THE MARYLAND-NATIONAL CAPITAL PARK AND PLANNING COMMISSION

MEMORANDUM

REVIEW TYPE: Site Plan Review
APPLYING FOR: Approval of 27,077 gsf commercial office on 2.61 acres
PROJECT NAME: Gateway Park
CASE #: 8-02006
REVIEW BASIS: Sec. 59-D-3, M. C. Zoning Ordinance
ZONE: I-3
LOCATION: W quadrant, intersection of Father Hurley Boulevard and Lullaby Road
MASTER PLAN: Germantown
APPLICANT: Germantown Station Limited Partnership, Wm. F. Asher, Gen'l. Partner
FILING DATE: February 20, 2002
HEARING DATE: April 18, 2002

PROJECT DESCRIPTION: Proposal

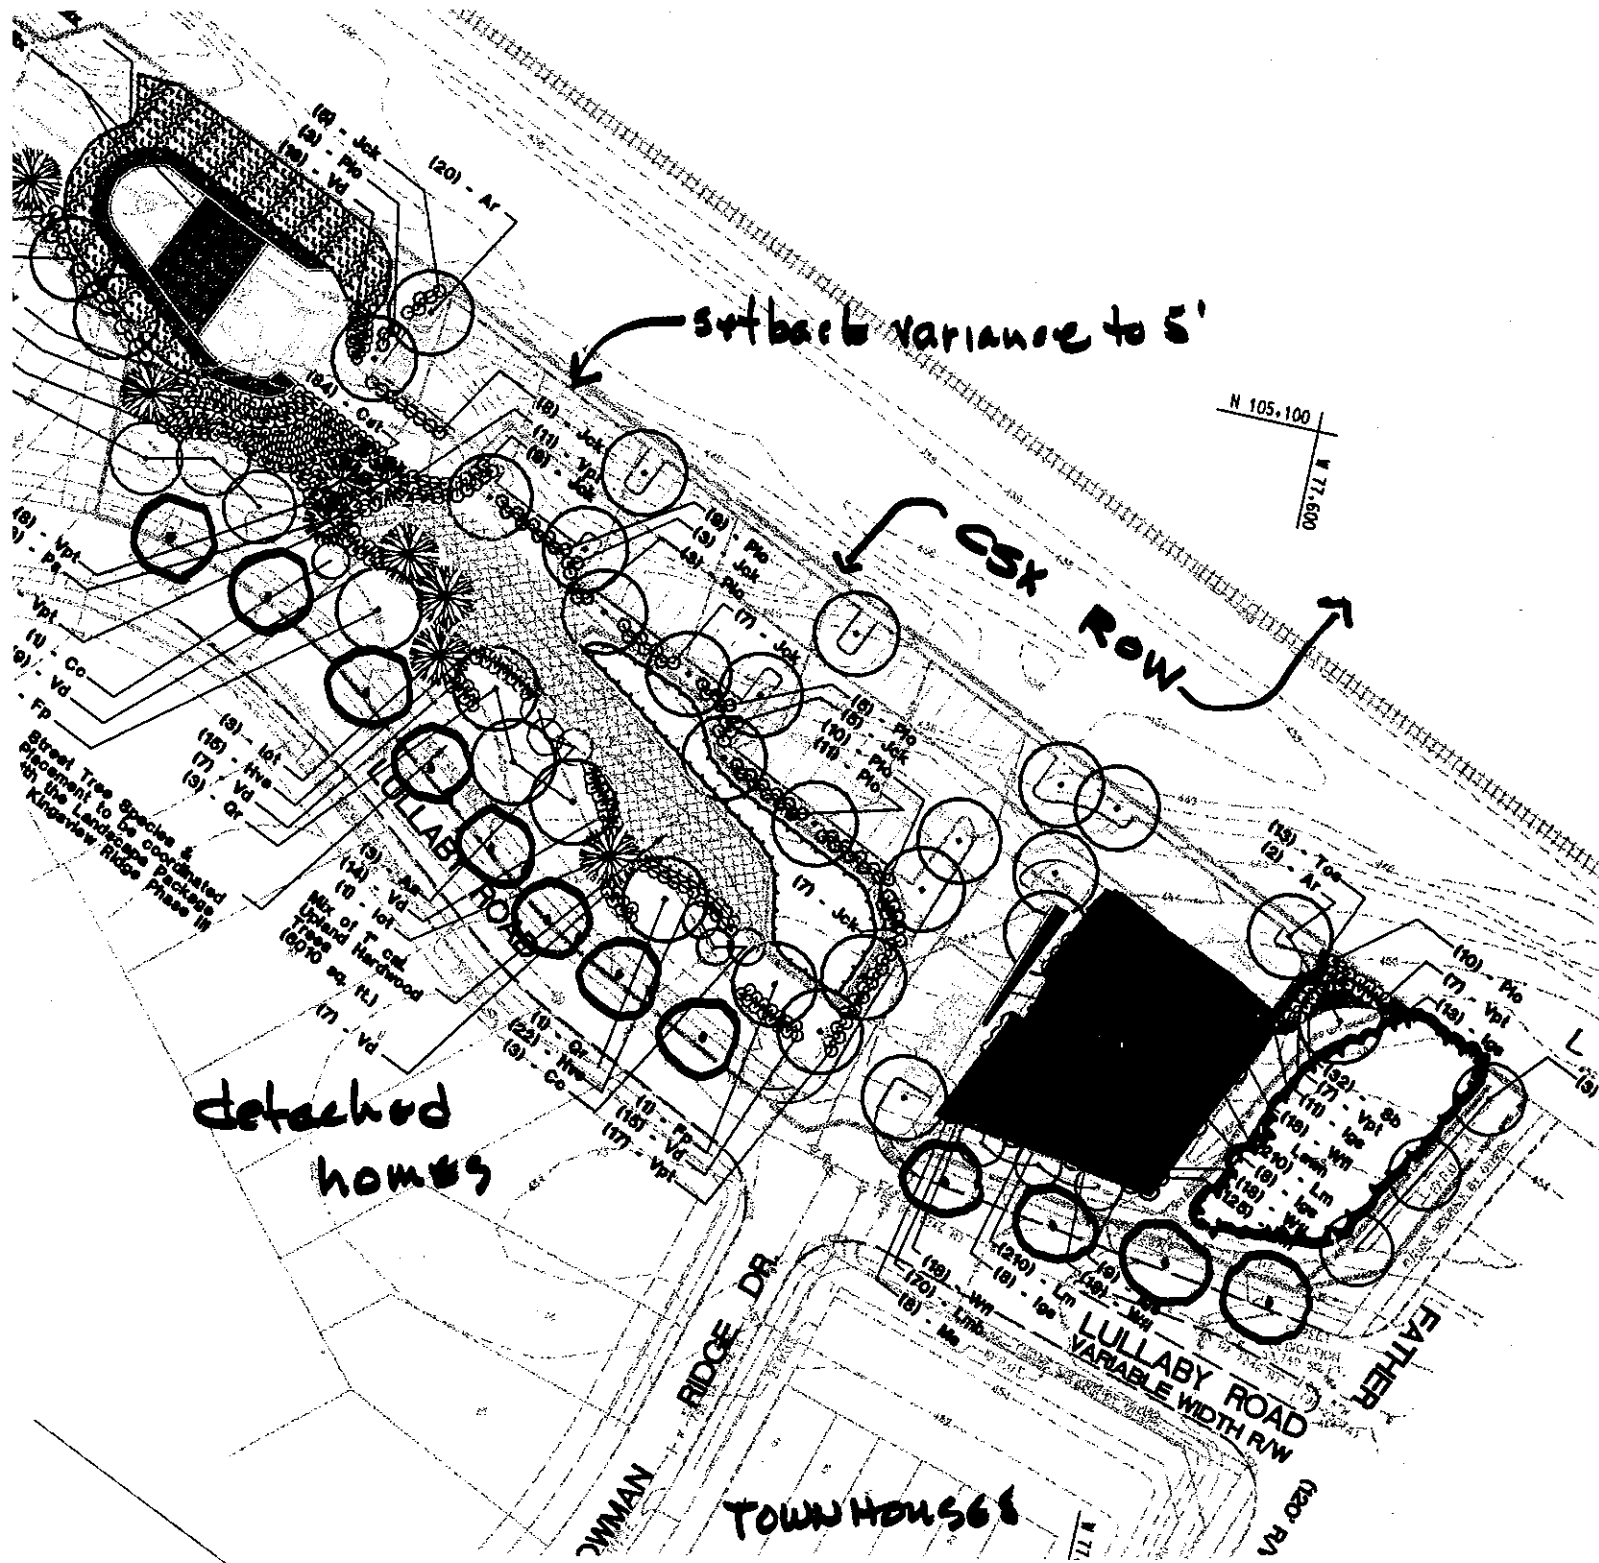
1. Standard Conditions dated October 10, 1995, Appendix A
2. Provide painted crosswalk across driveway
3. Designate street trees along Lullaby and curb between driveway and Father Hurley as proposed on signature set
4. Traffic Mitigation Agreement must be approved and received in final form prior to release of signature set
5. Conditions of DPS letter of July 26, 2001
6. Conditions of Transportation Planning staff memo referring to DRCM of March 11, 2002
